### Band Room SOG

**Project:** 23050. / Northern Lebanon MSHS Additions & Renov  
345 School Drive  
Fredericksburg, PA 17026

RFI #: GC-042

RFI Title: F119 Band Room Flooring

Drawing References: A1.7,

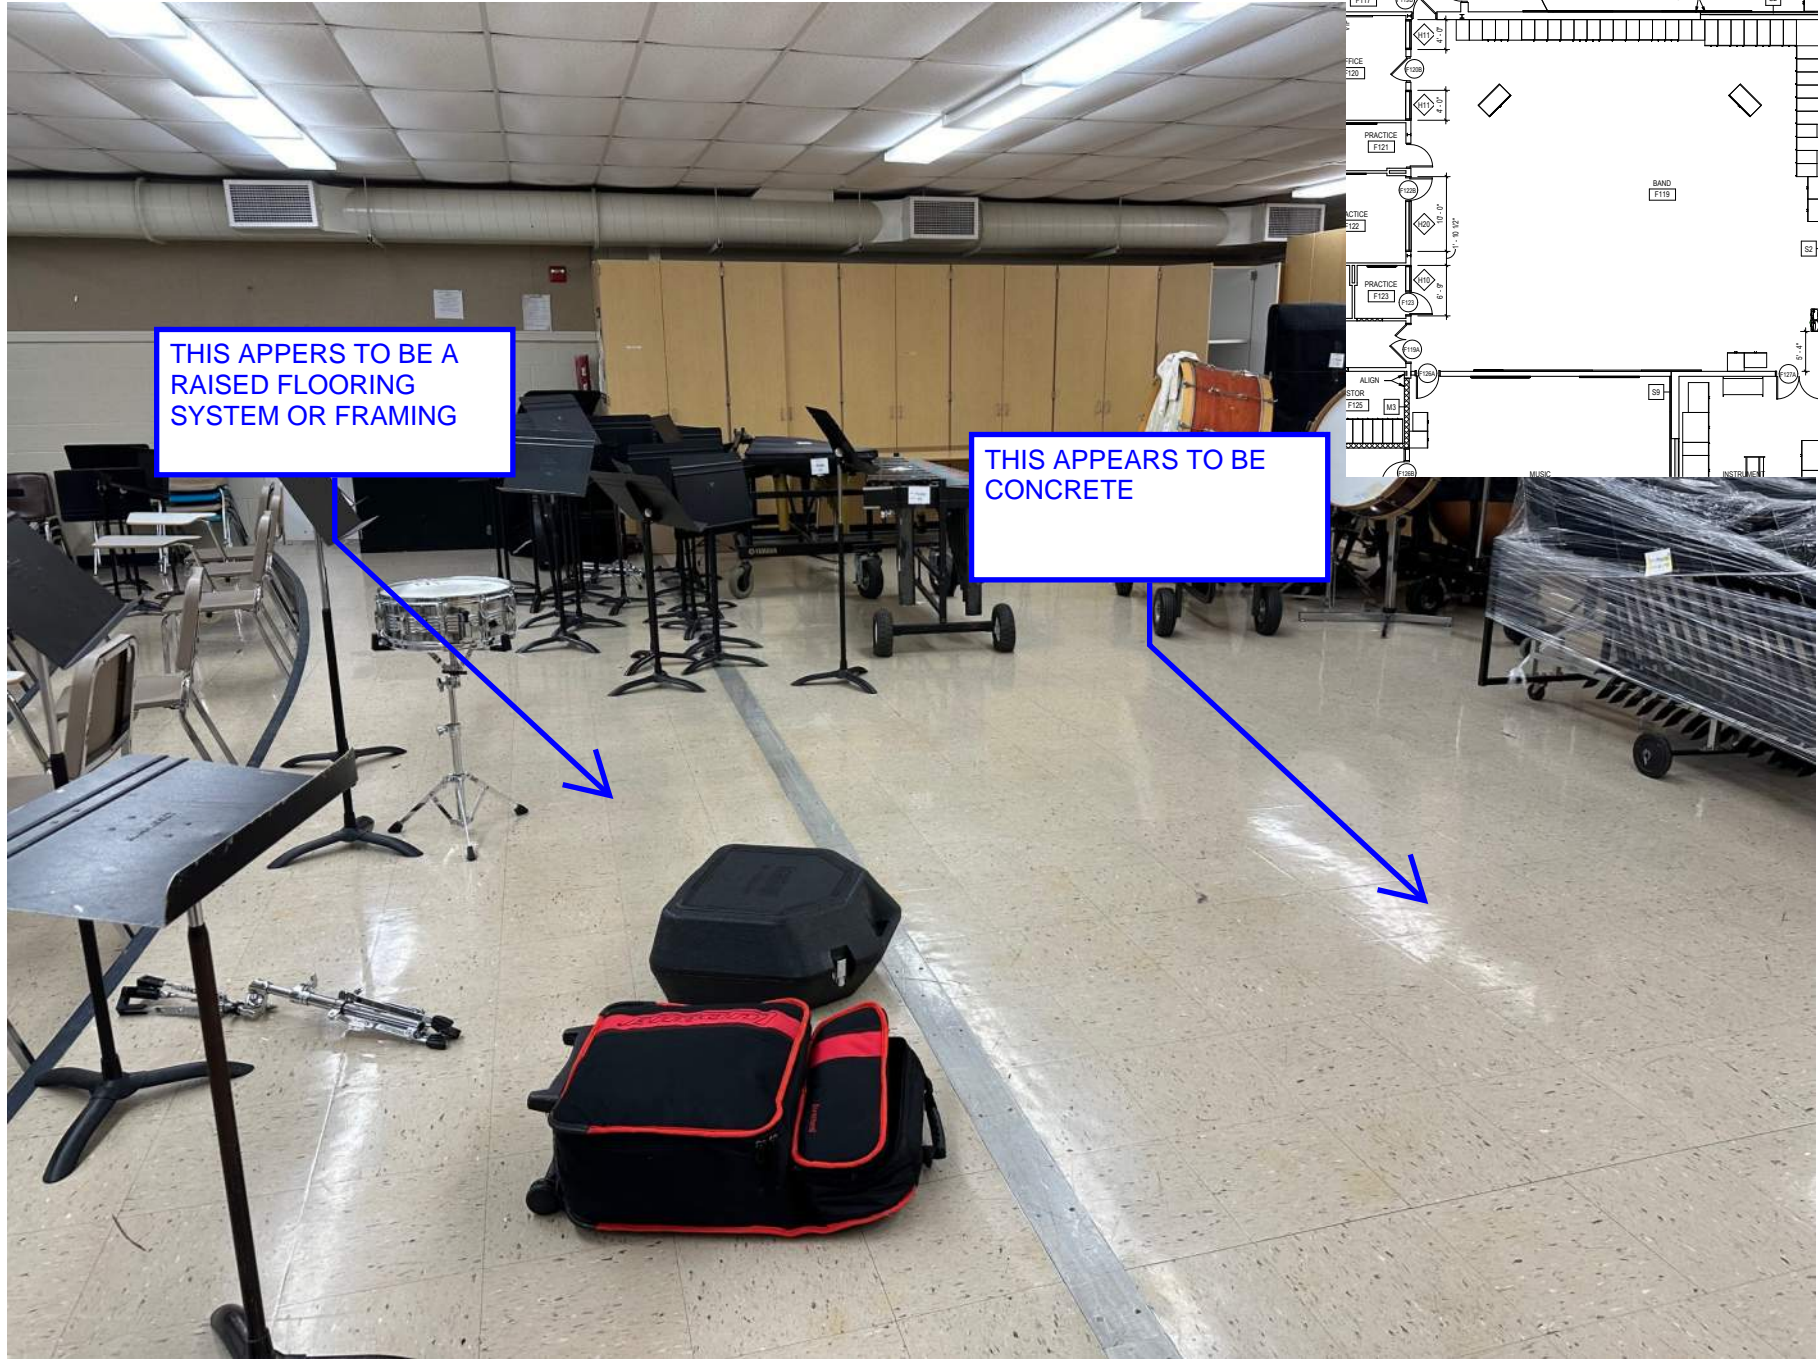
Description:  
In reviewing the band room F119, there is a joint cover at the top of the steps and it appears the raised area is a concrete slab, please advise how to resolve this as the demo drawings noted to remove the existing flooring, but a new door is being added into the space to the adjacent storage room at a lower elevation.

Response:  
As discussed via phone on Thursday 06/06, the back part of the band room was an addition that went in subsequent to the original construction. The concrete floor slab and fill can be removed and new floor slab installed to match the floor level of the rest of the band room. The existing foundation walls appear to extend low enough for the new floor slab to be installed against them.

In reviewing with the owner, this area does need to remain in phase 1. Should scheduling of this slab removal impact the ability to turn the room over at the start of the school year this fall, NLSD would like to know how much additional time is needed.

Finally, at the contractor's option, a temporary opening may be cut in the wall between the band room and the choral room to use the existing band room fill as new fill for the choral room in lieu of the specified geofoam.

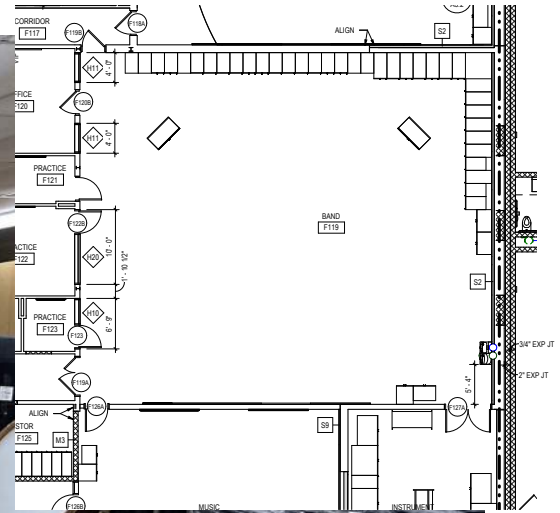
THIS APPEARS TO BE A RAISED FLOORING SYSTEM OR FRAMING

THIS APPEARS TO BE CONCRETE
